Product Change Notification

Change Notification #: 113289 - 00
Change Title: Intel® Server System R2224GZ4GC4
PCN 113289-00, Product Design
Update the System Rear Panel
Date of Publication: October 13, 2014

Intel is implementing the following changes on the Intel® Server System R2224GZ4GC4:

Figure One

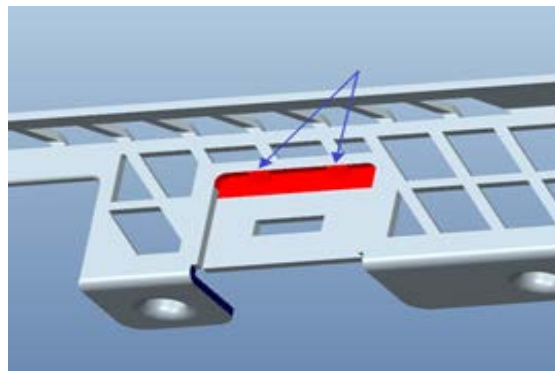
1. Update the one big center joint to two smaller joints so that the joints will not conflict with the LAN cable connector latch. See the Figure One.

Figure Two

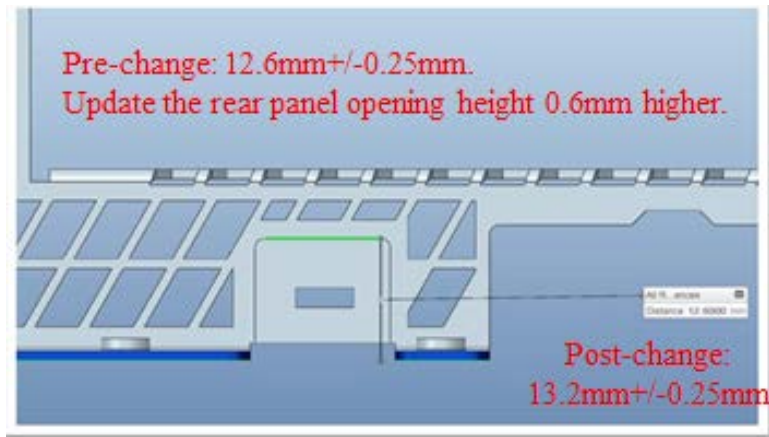
2. Update the rear panel opening height 0.6mm higher to improve the flexibility for the cable latch. The previous height was 12.6mm \pm 0.25mm. The updated height is 13.2mm \pm 0.25mm. See the Figure Two.

Figure Three

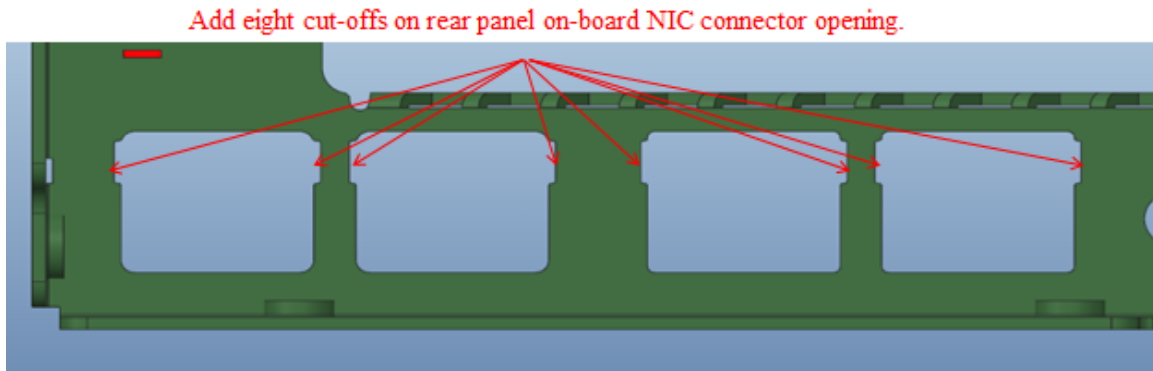
3. Add eight cut-offs around the on-board NIC (Network Interface Controller) openings to improve the LED visibility. See the Figure Three.
